RE: Consolidated GHG PSD Permit Application
Diamond Shamrock Refining Company, L.P., a Valero Company
Valero McKee Refinery – Crude Expansion Project
Sunray, Moore County, Texas

Re: Updated Application for a Prevention of Significant Deterioration Air Quality Permit for Greenhouse Gas Emissions – Crude Expansion Project
Diamond Shamrock Refining Company, L.P., a Valero Company
Valero McKee Refinery
Sunray, Moore County, Texas

Valero McKee Refinery
Figure 2-1 Process Flow Diagram

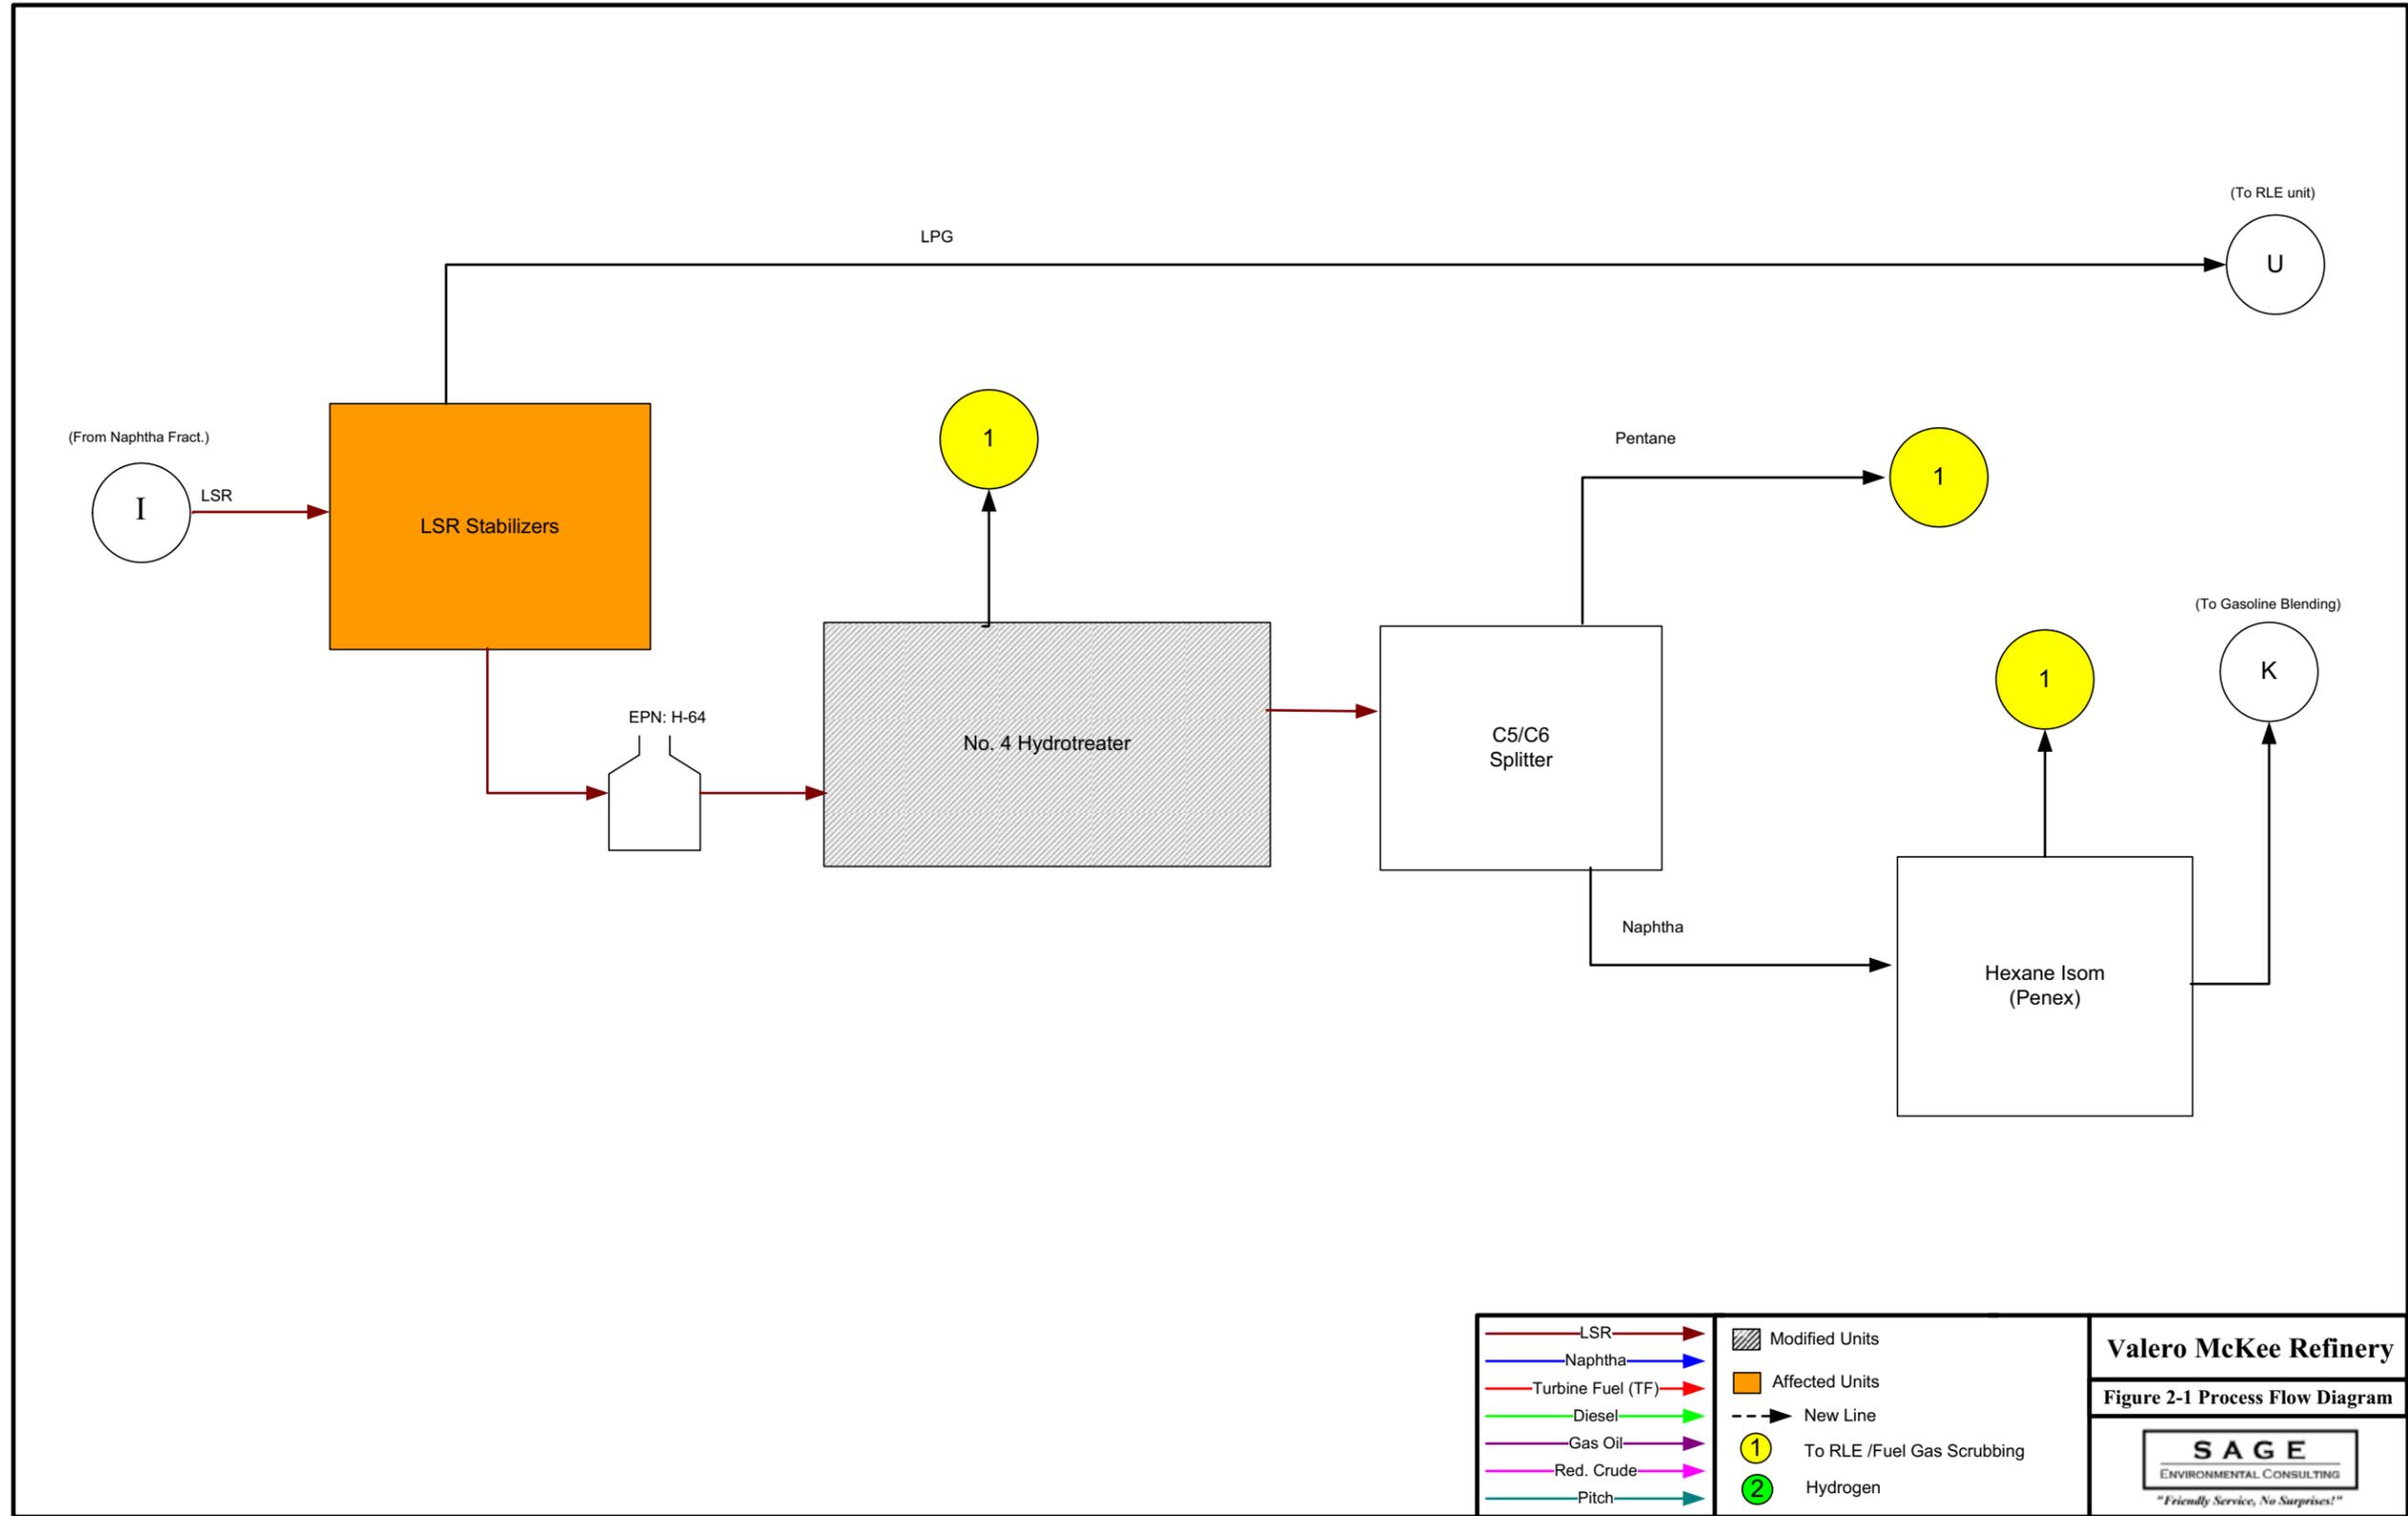
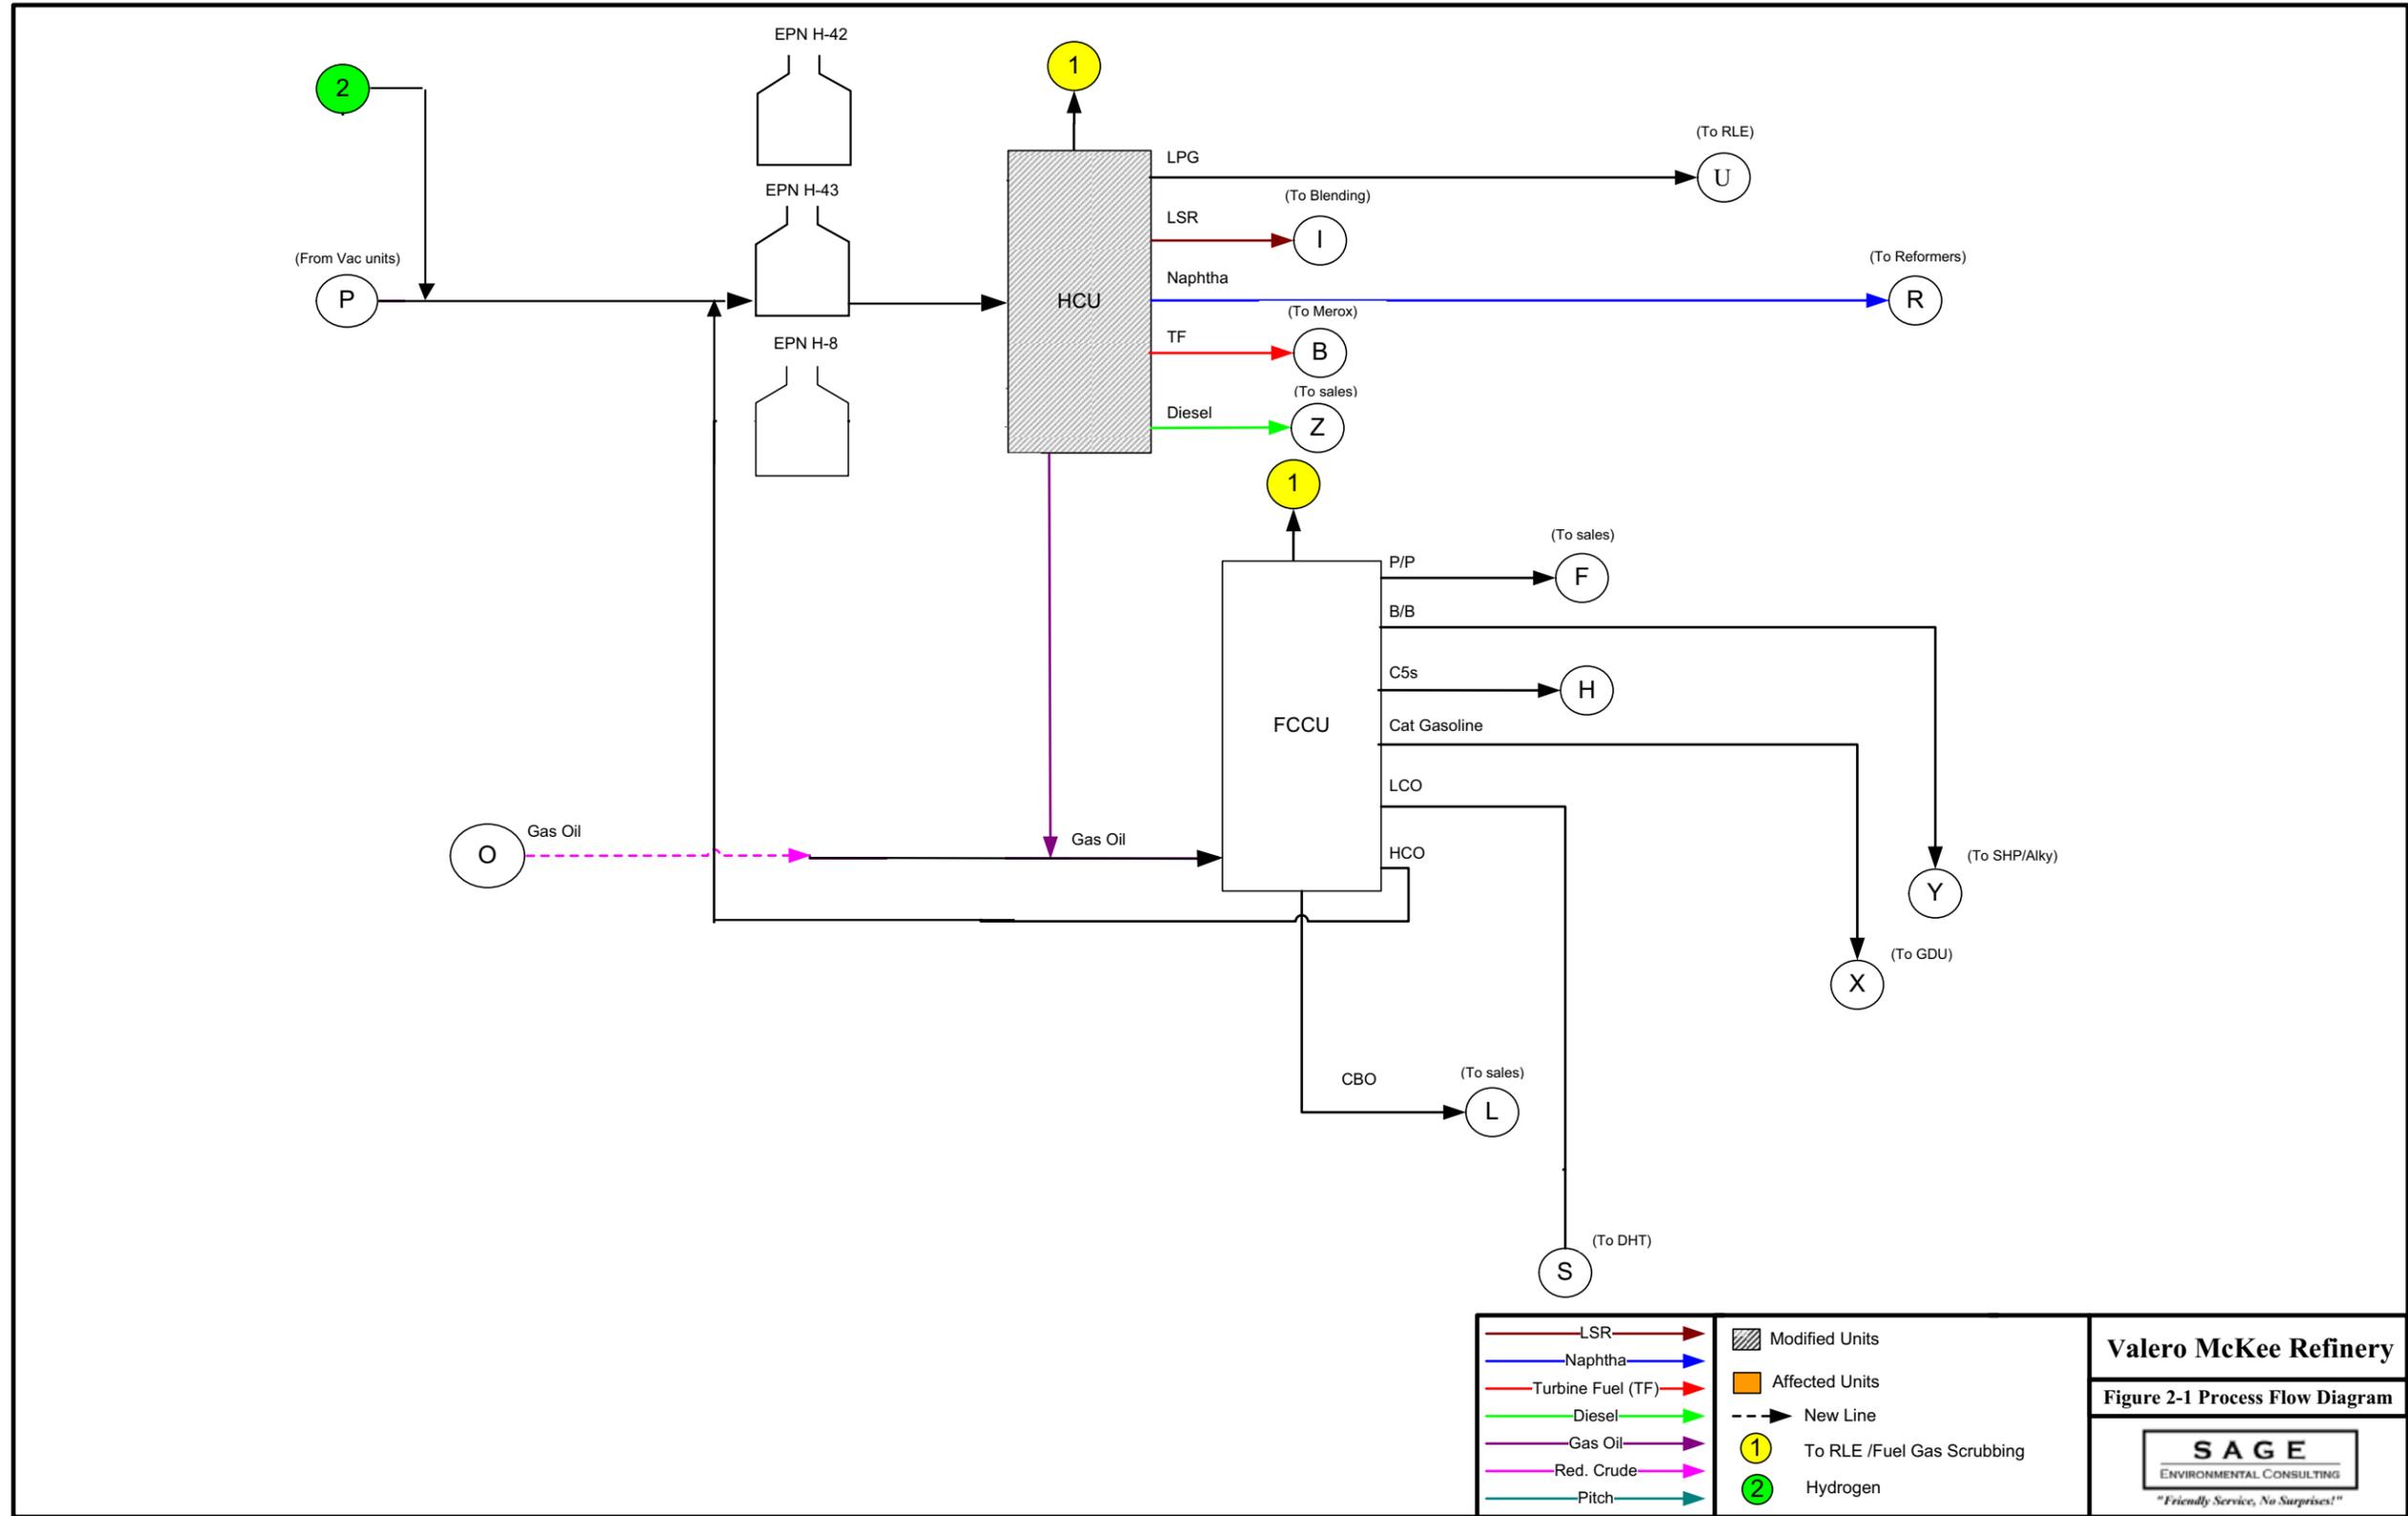
- 1. Figure 2-1 of the application provides a Block Flow Diagram for the entire refinery. Please add simplified block flow diagrams for each process unit indicating the emission points associated with each unit and similar to Figure 2-1. Please indicate if the unit was considered new, modified or affected by the project.**

The Merox unit is identified as modified in overall block flow diagram in Figure 2-1 as well as the description in Section 3. Fugitive emission increases were calculated in Table B-8 and are included in Table B-1 as “Additional Fugitive Components” (Modified). No materials regarding the Merox unit are being revised in this response.
